Replacement of fuel pumps for ROTAX® Engine Type 912 (Series)

ATA System: 73-00-00 Fuel system

Replacement of fuel pumps for ROTAX® Engine Type 912 (Series)

Fig. 1

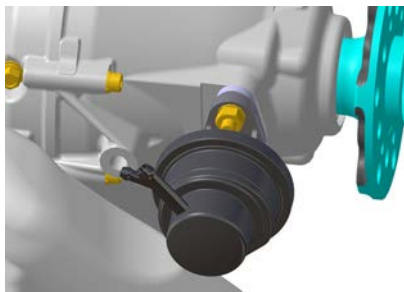
3.1.1) Removal of fuel pump part no. 892542 (without crimped hose assembly), see Fig. 1

Step	Procedure
1	Remove fuel hoses as per aircraft manufacturers instructions. NOTE: Make note of orientation of the hoses (inlet/outlet).
2	Loosen hex. nuts (13 mm/0.51 in) and remove fuel pump with lock washer A8 and insulating flange (gasket).

Fig. 2

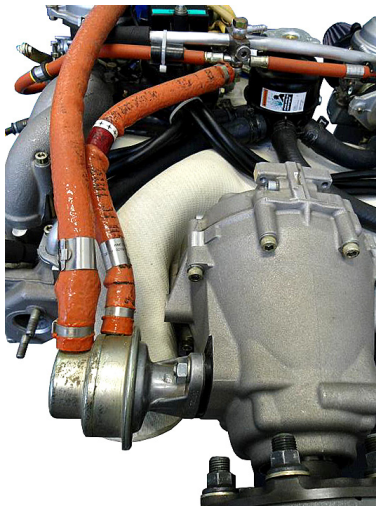
3.1.2) Removal of fuel pump part no. 892546 (with fire sleeve), see Fig. 2

Fig. 3

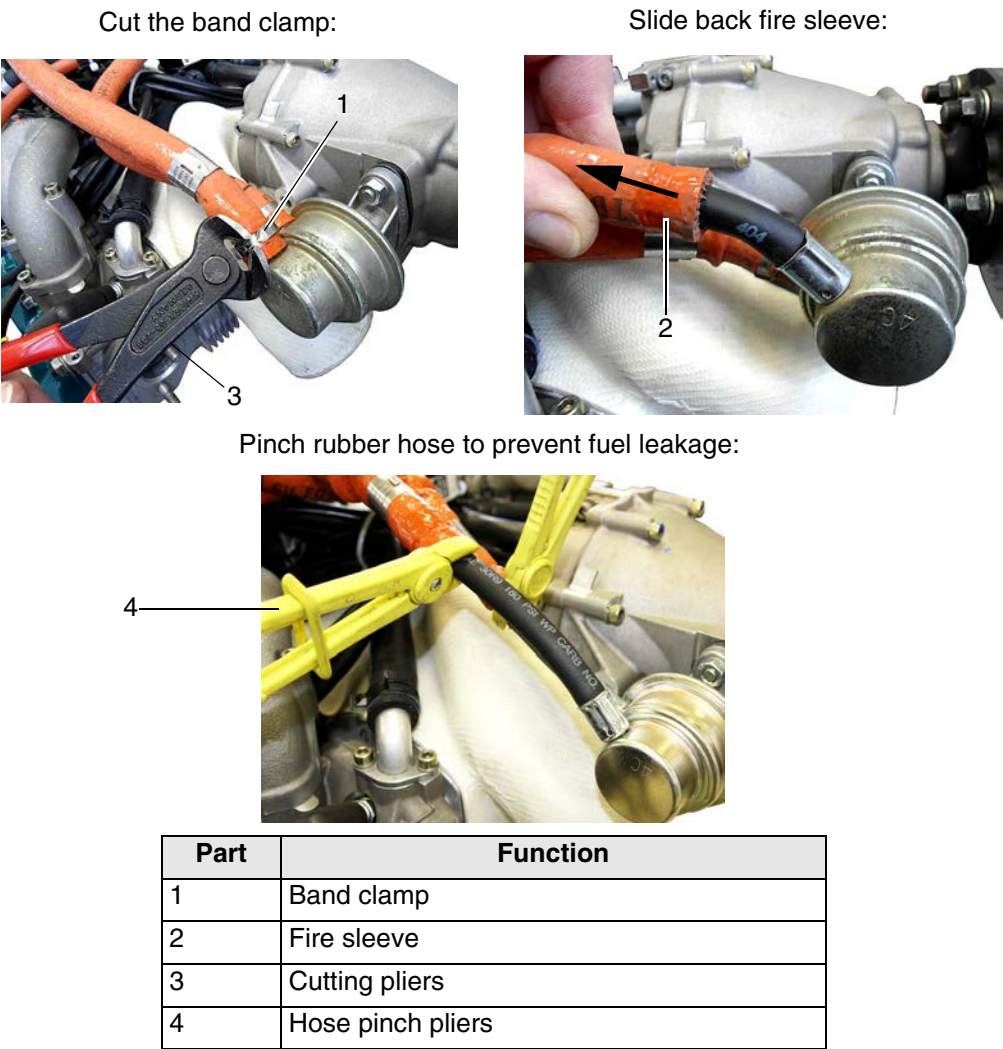
The following work steps are necessary (see Fig. 3):

Step	Procedure
1	Cut off the 1-ear clamp (1) of fire sleeve (2) with cutting pliers (3).
2	Slide back the fire sleeve (2) to make fuel hose accessible for cutting.
3	Pinch off the fuel hose with hose clamp pliers (4).

Fig. 4

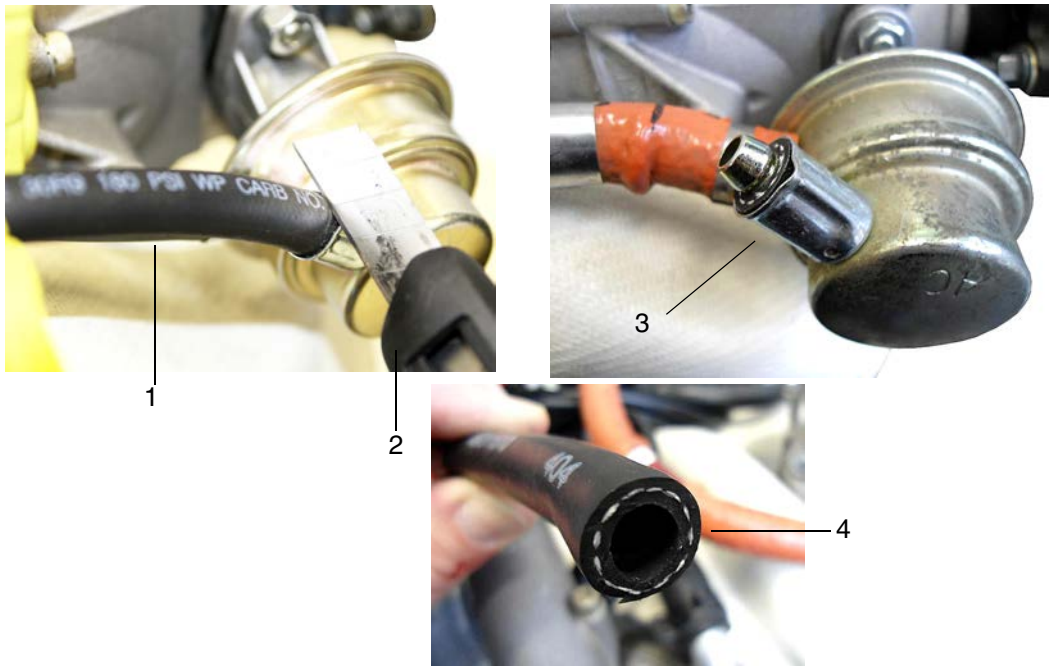
NOTE: Cut off the fuel hose with a very sharp knife, so that no cutting residues are produced. See Fig. 4.

Step	Procedure
4	The cut should be made adjacent to the crimped ferrel, to avoid losing any needed length. The fuel hose is reduced by approx. 20 mm (0.79 in.). NOTE: Make note of orientation of the hoses (inlet/outlet) A clean cut surface is very important!
5	Repeat procedure at the second fuel hose assy.

Fig. 6

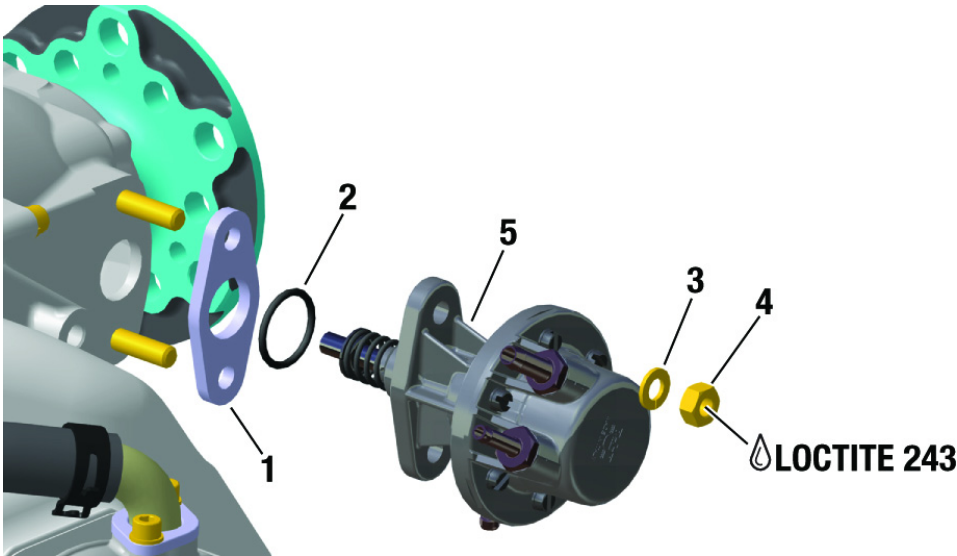
3.2) Assembling of fuel pump assy. part no. 893110

In addition to the insulating flange (gasket) also replace the O-ring at reassembly or assembly of the fuel pump.
Both parts are included in the set of fuel pump assy.

Ensure the O-ring is located in the recess in the fuel pump, before installing the fuel pump!

Step	Procedure
1	Install fuel pump (5) with new insulating flange (gasket) (1) and O-ring (2).
2	Secure new hex. nuts M8 (4) and lock washer A8 (3) with LOCTITE 243 and tighten them evenly. Tightening torque 15 Nm (133 in.lb).

Fig. 7

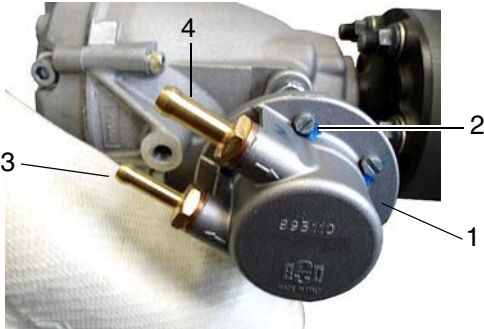
See Fig. 7.
The fuel pump cover (1) must not be opened for inspection. Check the security markings (witness paint) (2).
Check the connecting nipples (3)+(4) for tightness. If necessary secure them with LOCTITE 243. Tightening torque 10 Nm (88.5 in.lb).
- Graphic

Step	Procedure
1	Connect the hose from the fuel tank to the connecting nipple identified as 4 in Fig. 7.
2	The hose that goes to the carburetors should be connected to the connecting nipple identified as 3 in Fig. 7. NOTE: After installation of the hoses ensure the fuel tap is turned back ON.

Fig. 8

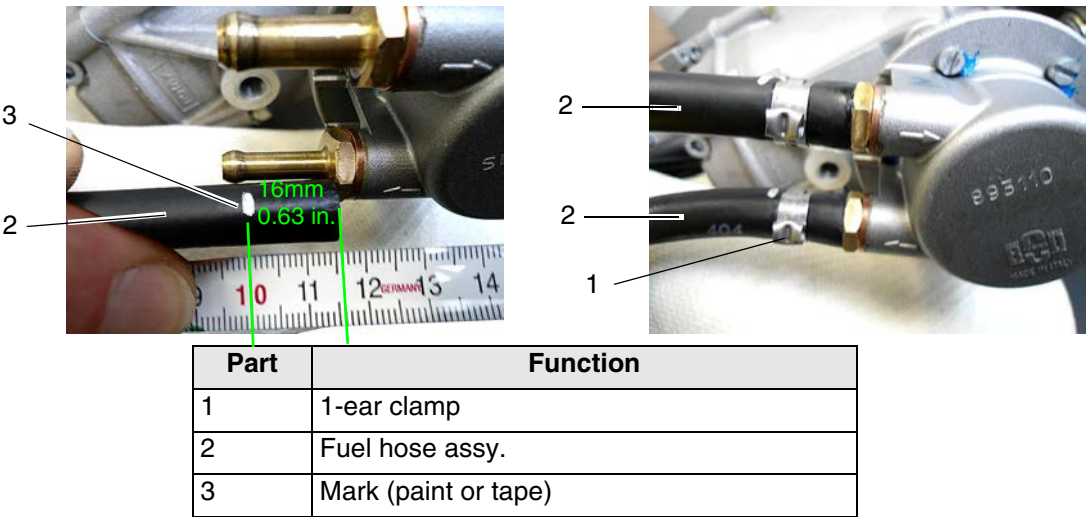
3.4.2) Assembling of the fuel pump part no. 893110 when replacing fuel pump part no. 892546

Step	Procedure
2	Before the fuel hose (2) is fitted with a 1-ear clamp (1), the two fuel hoses have to be marked (3) 16 mm (0.63 in.) from the end of the hose (2).
3	Slide all 4 1-ear clamps (1) on the fuel and fire sleeves. NOTE: Clamps part no. 853313/851663 on fire sleeve and clamps part no. 851463/851453 on fuel hose.
4	Slide the fuel hoses (2) onto nipple completely up to the end stop.
5	Crimp 1-ear clamp (1)- outlet side part no. 851463 with suitable crimp pliers . NOTE: The edge of the 1-ear clamp (1) must align with mark (3) from fuel hose (2) , because otherwise there is too little space for the 1-ear clamp (1) of the fire sleeve.
6	Repeat steps on inlet-side with 1-ear clamp (1) part no. 851453 for fuel hose assy. (2).

Fig. 9

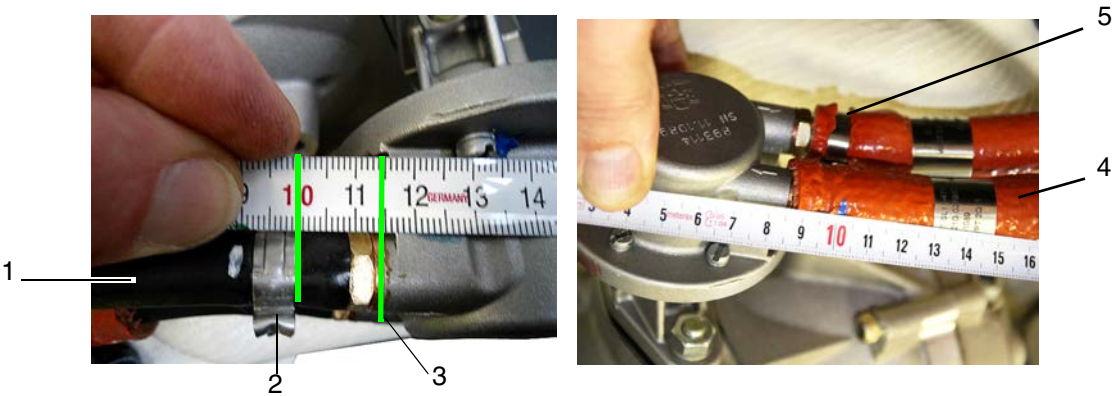
The distance from the 1-ear clamp (2) to the nipple flange (3) has to be measured, so that the outer 1-ear clamp (5) can be mounted on the fire sleeve (4) in the correct position.

Step	Procedure
1	Measure the distance at fuel hose assy. (1) from 1-ear clamp (2) to nipple flange sealing surface (3) and mark the fire sleeve (4) correspondingly. NOTE: The clamp securing the fire sleeve should be as close as possible but without impeding on the fuel hose clamp

Fig. 10

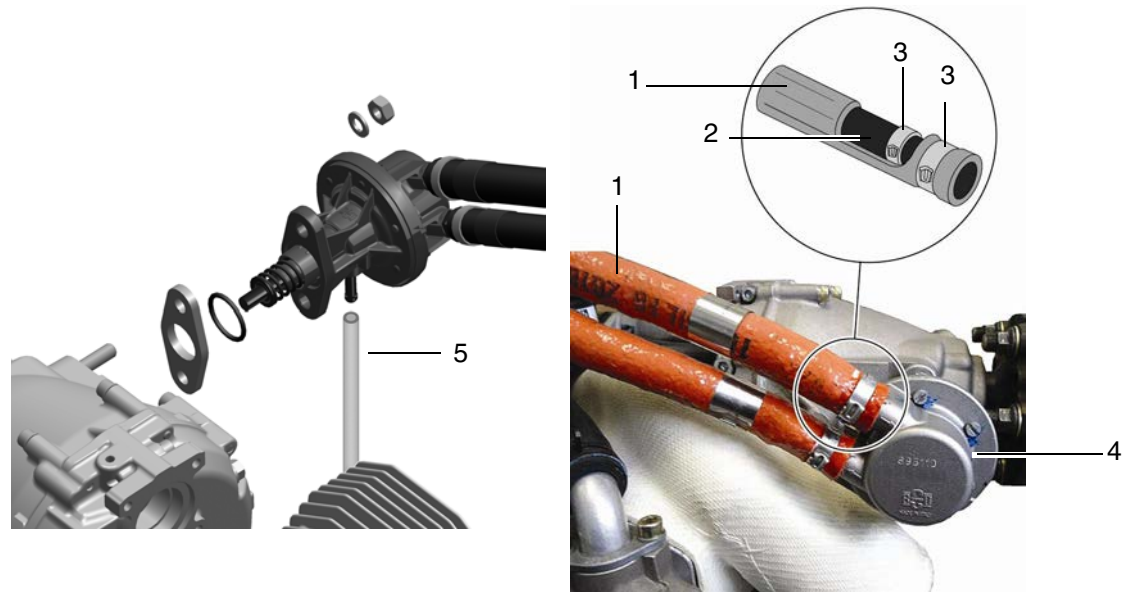
A drain line must be installed, that in the event of a internal leak any fluid is drained to a suitable location/position. See therefore Installation Manual of the relevant engine type and SI-912-020.

Step	Procedure
2	Push fire sleeve (fuel inlet) to stop and mount 1-ear clamp (17.8-21.0 mm/0.70-0.83 in.) with suitable crimp pliers.
3	Repeat steps for fire sleeve (fuel outlet) (22.4-25.6 mm/0.88-1.01 in.).
